Overview: Production error in version 1.0 harnesses; The immobilizer wire (orange/black) is in pin position #4 instead of pin position #5. Although an effort to correct the issue was made, some quantity of harnesses did get shipped before the issue was spotted. We are advising to inspect the harness BLADE connector before attempting to install harness or program the module. This issue is not known to affect the version 2 harnesses, which require no modification.

Overview: Early versions of the FTI-STP1 harness require modification for **automatic transmission (AT)** applications, some of the product was able to be modified before release, but a small quantity was released without modification.

FTI-STP1: Vehicle Coverage and Preparation Notes

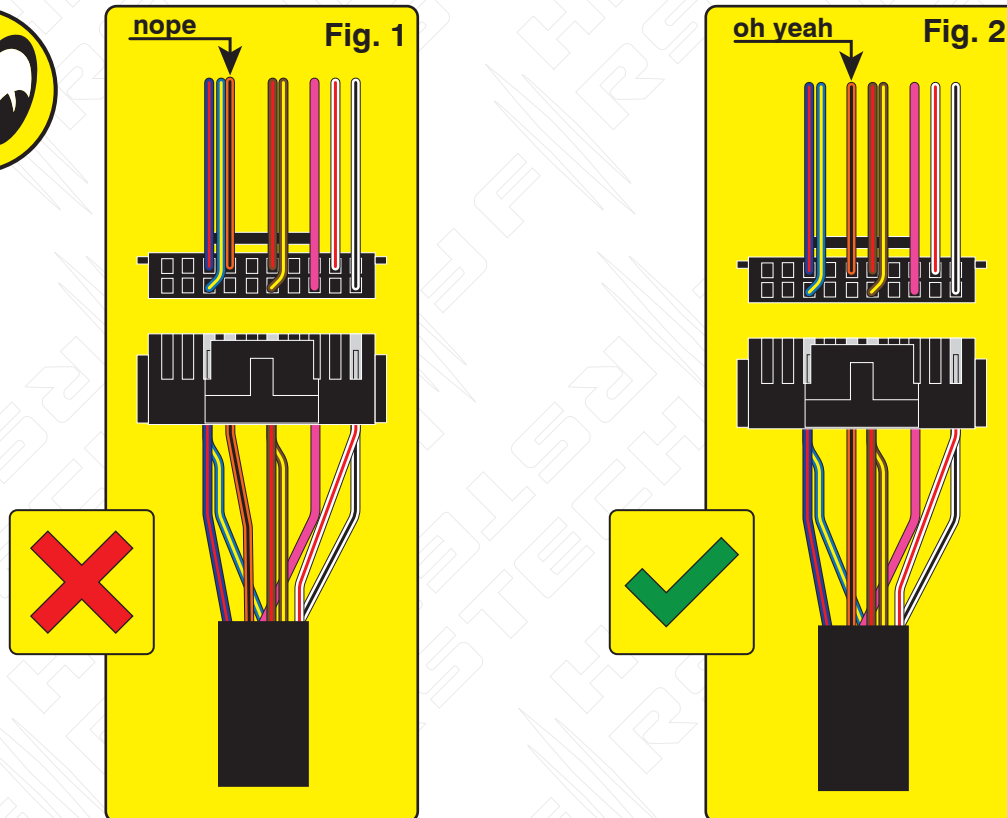
Issue: Module fails to program correctly to vehicle, does not allow the vehicle to be remote started.

Correction: Step 1.) Locate the orange/black wire and confirm whether it is positioned as illustrated in Fig. 1 or Fig. 2. If the wire is as illustrated in Fig.1, proceed with Step 2 through 5 and complete the repair procedure outlined, if the wire is as illustrated in Fig. 2, correction is not necessary, proceed with harness installation and module programming.

Step 2.) Using a pick, lightly depress the catch that secures the terminal in the housing then remove the wire and terminal from the housing.

Step 3.) Using a fine tip razor or utility knife, insert the blade beneath the terminal catch and raise it slightly, so that it can be reused to secure the terminal when reinserted into the BLADE connector housing.

Step 4.) Refer to Fig. 2 for correct position of the orange/black wire (next to brown/red) then reinsert the terminal, pressing lightly until the catch 'snaps' into place, securing the terminal in the connector housing.

MODIFICATION REQUIRED FOR A/T APPLICATIONS, ONLY WITH v 1.0 HARNESS

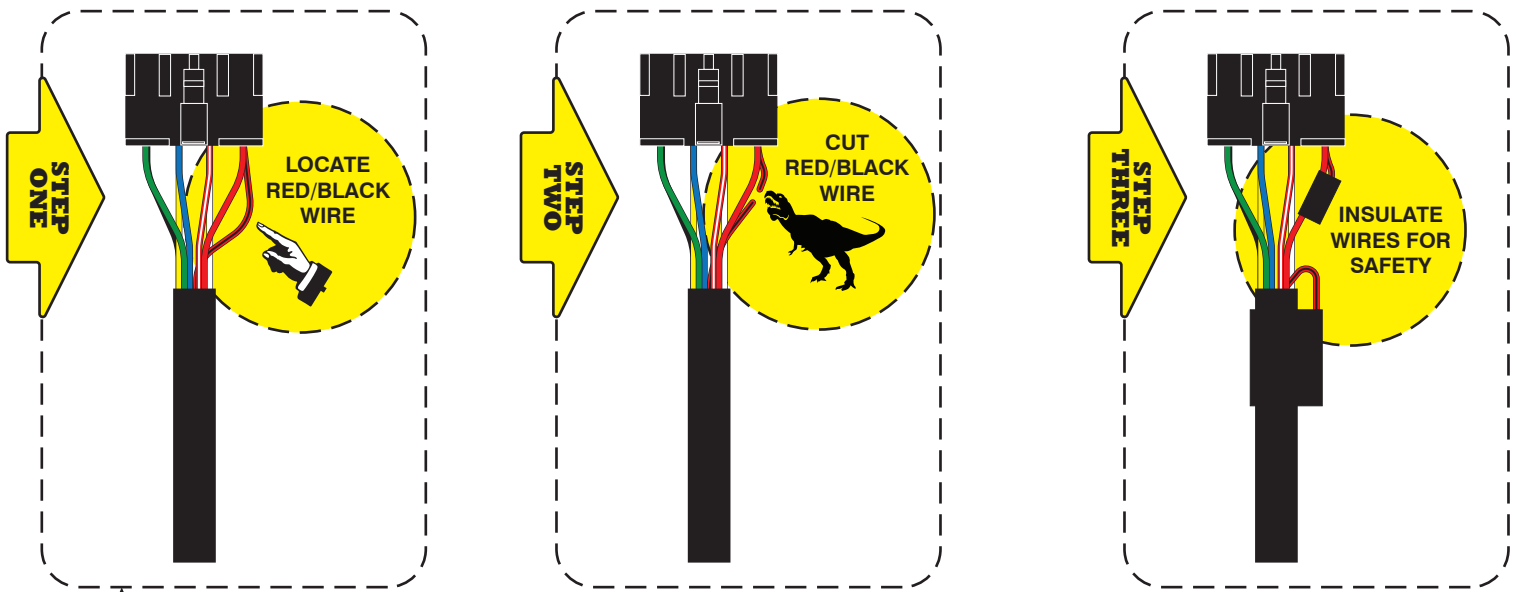
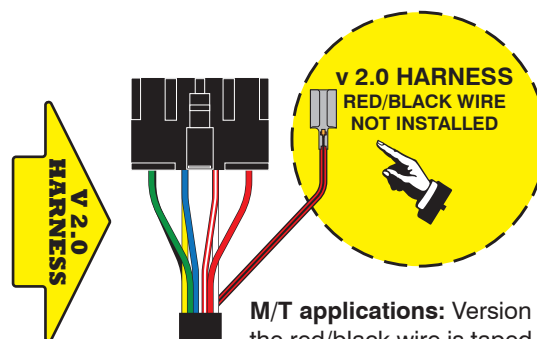
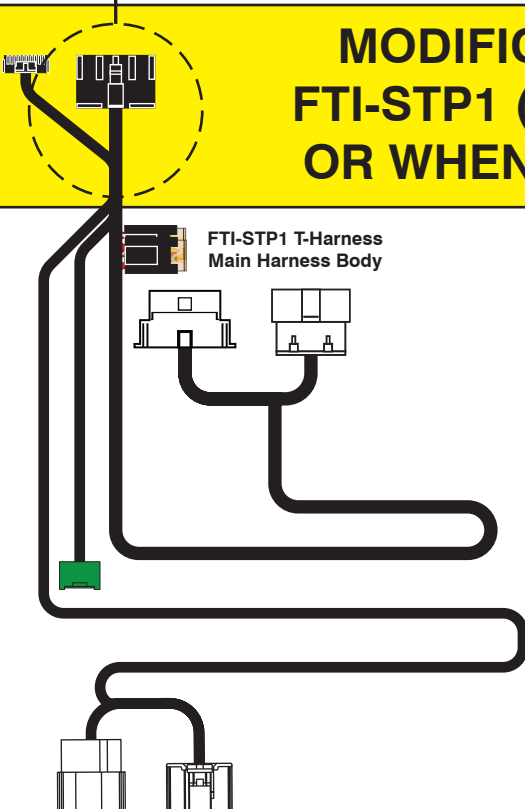
Issue: The FTI-STP1 T-harness has been designed to be compatible with A/T (automatic transmission) & M/T (manual transmission) applications, but due to an oversight in early production runs, the selection was defaulted to M/T mode.

Using a harness configured for an M/T application, in an A/T equipped vehicle, could result in vehicle module damage, it is advised that the harness be returned to A/T mode before installation in vehicles equipped with an automatic transmission.

Correction: Locate the **red/black (+ Clutch)** wire provided in the CN1 connector of the main harness assembly. Cut the **red/black** wire, either flush to the CN1 connector, or leaving enough wire exposed so that you can insulate and secure the ends of the wire that remain after cutting. Insulate each of the remaining ends of the **red/black** wire and secure to prevent any possibility of a short circuit. **If the red/black wire has already been disconnected, no further modification is required for A/T applications**

MODIFICATION NOT REQUIRED WHEN USING FTI-STP1 (v 1.0) HARNESS IN M/T APPLICATIONS, OR WHEN USING THE FTI-STP1 (v 2.0) HARNESS

M/T applications: Version 2.0 harness, the red/black wire is taped to the main harness when shipped, and must be installed in the CN1 connector when installed.

A/T applications: Leave the red/black wire taped to the harness, it is not required for A/T applications
